DATE: June 20, 2019
TO: Mr. Michael A. Pettyjohn, PE
Division Engineer
Division 11
FROM: John C. Farley
Manager
Geographic Information Systems Unit
SUBJECT: 2019 District 3 Road System Changes

2019 Road System Changes

Project Name: LRS_13151_06-19
Date: 06/19/2019
County: WILKES

Reassignments

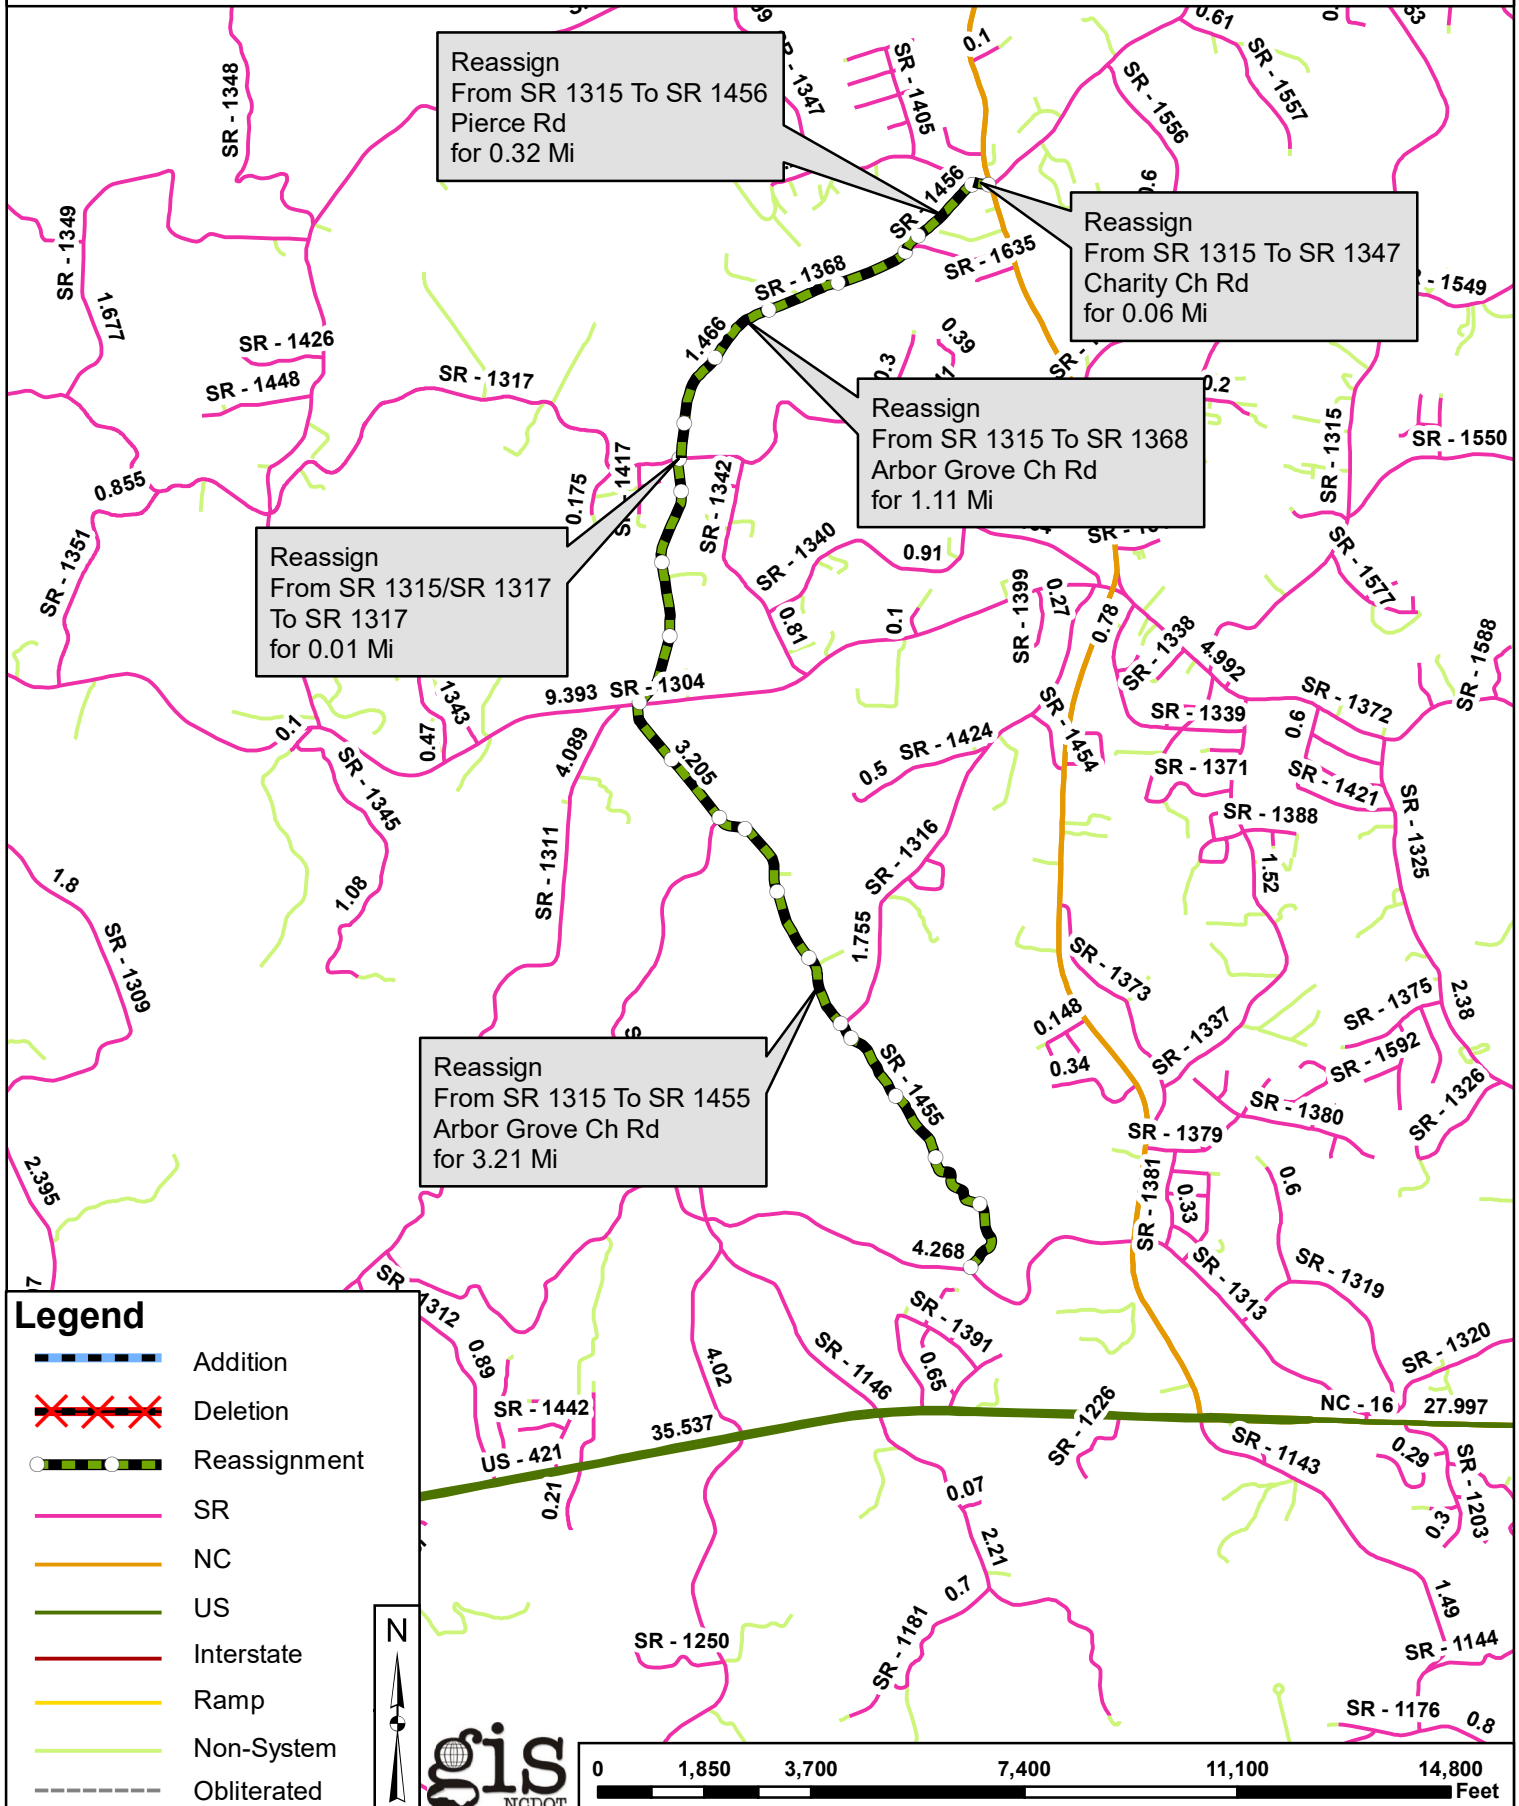
Existing Route	New Route	Street Name	Mileage	Map
SR 1315/SR 1317	SR 1317		0.01	
SR 1315	SR 1347	CHARITY CH RD	0.06	
SR 1315	SR 1456	PIERCE RD	0.32	
SR 1315	SR 1368	ARBOR GROVE CH RD	1.11	
SR 1315	SR 1455	ARBOR GROVE CH RD	3.21

Reassign
From SR 1315 To SR 1456
Pierce Rd
for 0.32 Mi

Reassign
From SR 1315 To SR 1347
Charity Ch Rd
for 0.06 Mi

Reassign
From SR 1315 To SR 1368
Arbor Grove Ch Rd
for 1.11 Mi

Reassign
From SR 1315/SR 1317
To SR 1317
for 0.01 Mi

Reassign
From SR 1315 To SR 1455
Arbor Grove Ch Rd
for 3.21 Mi
